Notice of Intent

Sundry ID: 2806844

Procedure Description: OXY PROPOSES TO PREP THESE WELLS FOR THE PA RIG. SEE ATTACHED PREP RIG STEPS AND WELL CONTROL PRECAUTIONS.

Procedure Description: OXY USA WTP LP respectfully requests approved to plug and abandon the subject well. The proposed plugging plan, current wellbore diagram and proposed wellbore diagram are attached.

Current Wellbore

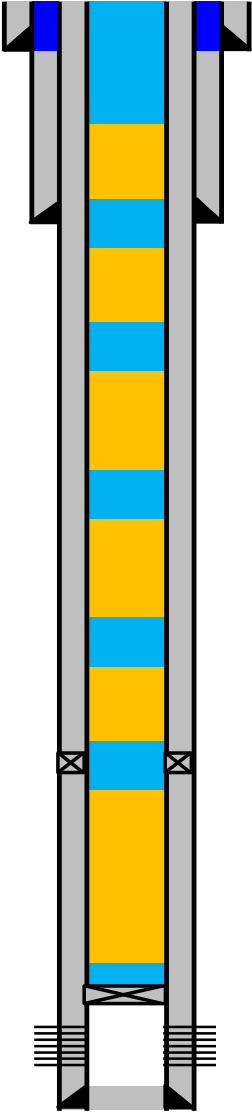
1. SET CIBP @ 7376'. SPOT ~~10~~ CLASS H CMT ON TOP 7376'-~~7326~~'. WOC AND TAG. ~~7376'-7252~~ 25 Sacks
2. RUN CBL 7300'-SURFACE.
3. SPOT ~~25~~ SX CLASS C CMT 6412'-~~6276~~'. WOC AND TAG. ~~27~~ Sacks 6412'-6248'
4. SPOT 25 SX CLASS C CMT ~~5850'-5714~~'. WOC AND TAG. ~~26~~ Sacks 5756'-5598'
5. SPOT 25 SX CLASS C CMT ~~3450'-3314~~'. WOC AND TAG. ~~25~~ Sacks 3051' to 2920'
6. SPOT 25 SX CLASS C CMT 2114'-1978'. WOC AND TAG.
7. SPOT 25 SX CLASS C CMT 1260'-1124'. WOC AND TAG.
8. SPOT 105 SX CLASS C CMT 547'-SURF. WOC AND VERIFY CMT AT SURF.

Sundry ID		2771577					
Plug Type	Top	Bottom	Length	Tag	Sacks	Cement Class	Notes
Surface Plug	0.00	100.00	100.00	Tag/Verify			
Fresh Water @ 350	296.50	400.00	103.50	If solid			
				If solid base no need to Tag (CIBP present and/or Mechanical Integrity Test), If Perf & Sqz then Tag, Leak Test all CIBP if no Open Perforations			
San Andres @ 497	442.03	547.00	104.97		89.00	C	Spot cement from 547' to surface. Verify at surface.

9.625 inch- Shoe Plug	1147.90	1260.00	112.10	Tag/Verify	25.00	C	Spot cement from 1260' to 1147'. WOC and Tag.
				If solid base no need to Tag (CIBP present and/or Mechanical Integrity Test), If Perf & Sqz then Tag, Leak Test all CIBP if no Open Perforations			
Glorieta @ 2060	1989.40	2110.00	120.60		25.00	C	Spot cement from 2110' to 1989'. WOC and Tag.
				If solid base no need to Tag (CIBP present and/or Mechanical Integrity Test), If Perf & Sqz then Tag, Leak Test all CIBP if no Open Perforations			
Bonesprings @ 3001	2920.99	3051.00	130.01		25.00	C	Spot cement from 3051' to 2920'. WOC and Tag.

If solid base no need to Tag (CIBP present and/or Mechanical Integrity Test), If Perf & Sqz then Tag, Leak Test all CIBP if no Open Perforations			
Wolfcamp @ 5706	5598.94	5756.00	157.06	ns	26.00	C	Spot cement from 5756' to 5598'. WOC and Tag.
DV tool plug	6248.38	6412.00	163.62	Tag/Verify	27.00	C	Spot cement from 6412' to 6248'. WOC and Tag.
				If solid base no need to Tag (CIBP present and/or Mechanical Integrity Test), If Perf & Sqz then Tag, Leak Test all CIBP if no Open Perforations			
CIBP Plug	7341.00	7376.00	35.00	ns	25.00	H	Set CIBP at 7376'. Spot 25 Sacks on top. (7376' to 7252') WOC and Tag.
Perforations Plug (If No CIBP)	7376.00	7830.00	454.00	Tag/Verify			
7 inch- Shoe Plug	7914.55	8095.00	180.45	Tag/Verify
